Bid Addendum 05

Project: Maritime Museum Education Center,
Beaufort, NC – Construction Phase Services

Date: August 2, 2024

SCO#: 24-27956-01A

4 PROMENADE SECTION B
SECTION
1/4" = 1'-0"

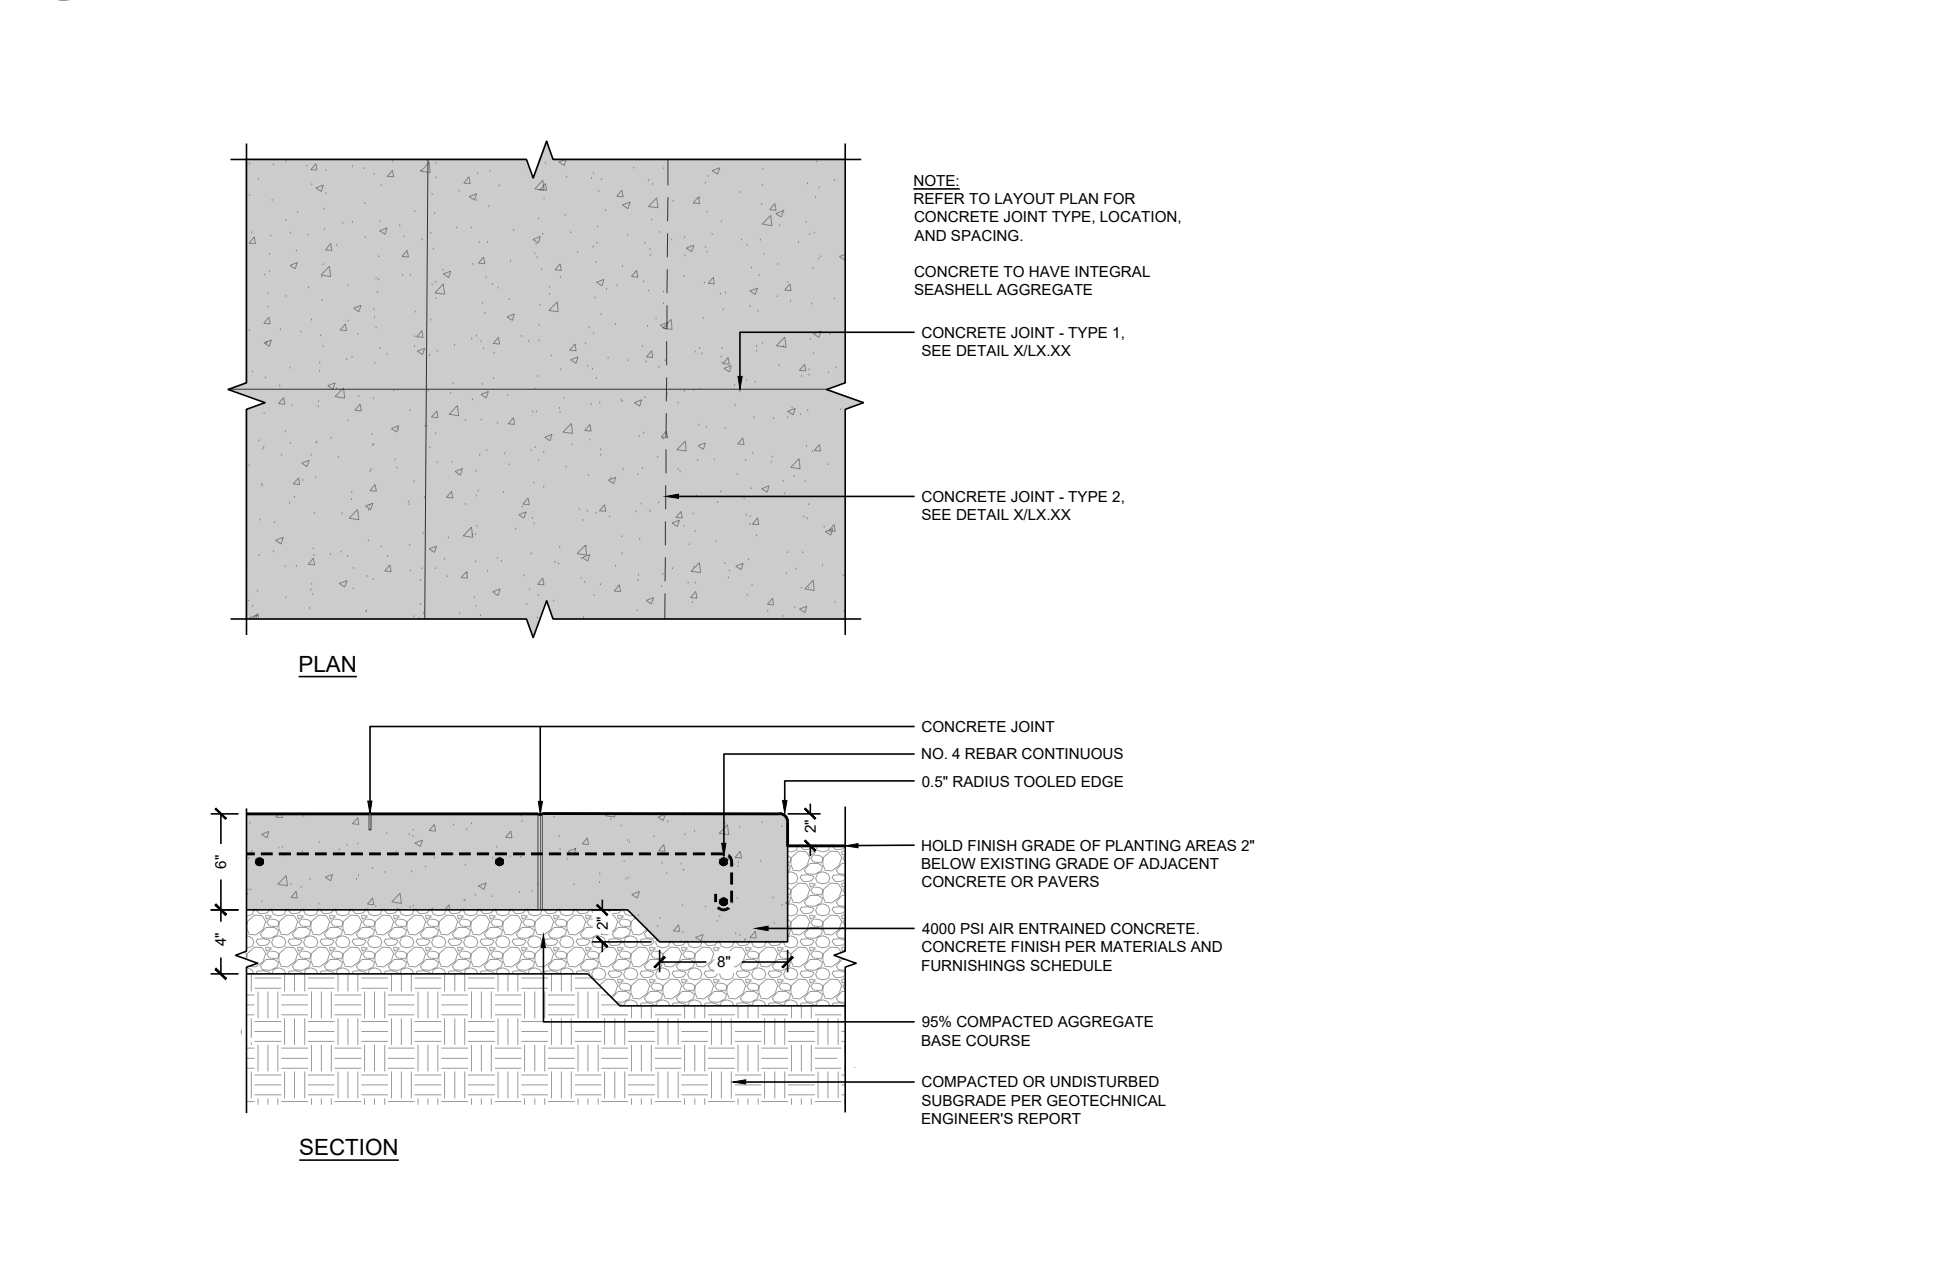
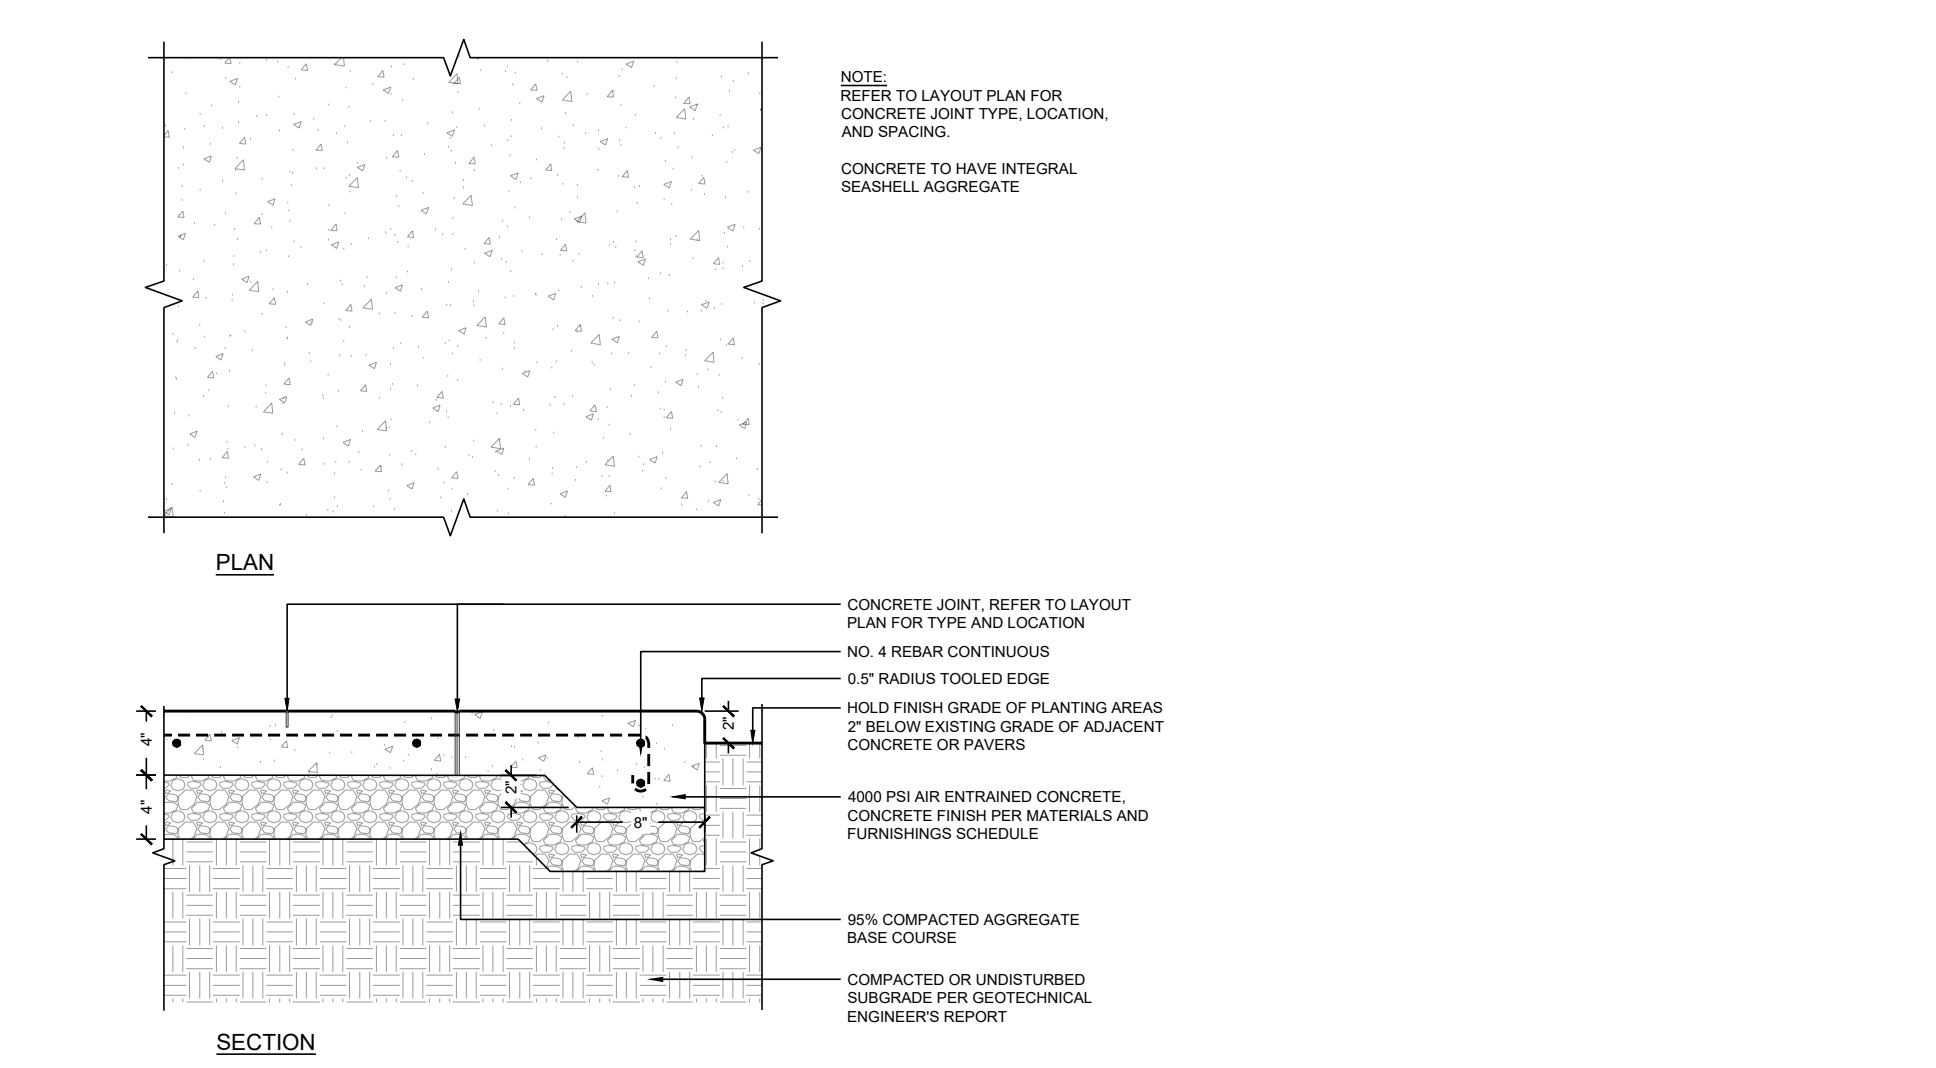
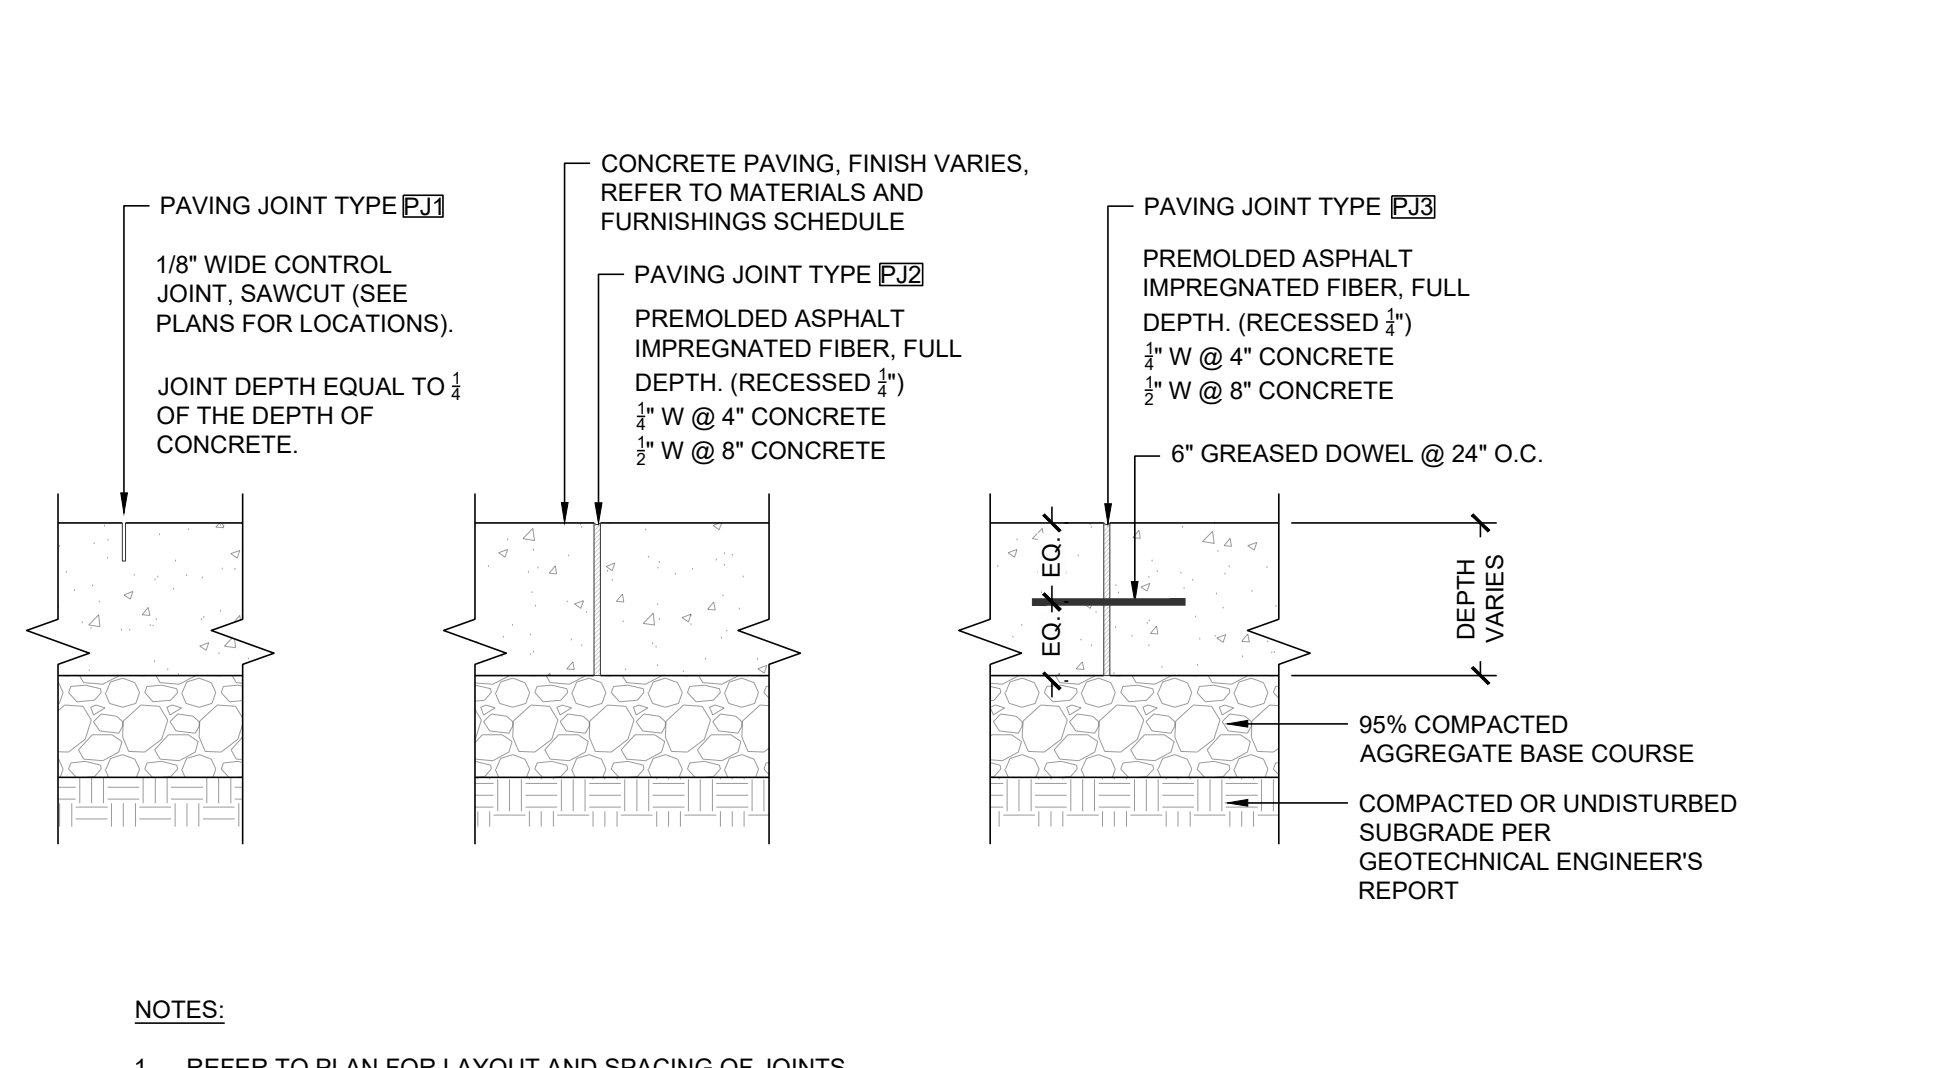
16. Sheet L4.00:
 - a. Detail 8 Grasspave2 Details has been added.
17. Sheet L4.00:
 - a. Detail 8 Grasspave2 Details has been added.
18. Sheet AE302
 - a. Sound Absorbing Wall callout has been added.

6. **QUESTION:** Please provide a cross-section for Grasspave (identified as P7 within Landscape drawings).
 - a. **RESPONSE:** Refer to attached sheet L4.00. Detail 8 Grasspave2 Detail has been added.
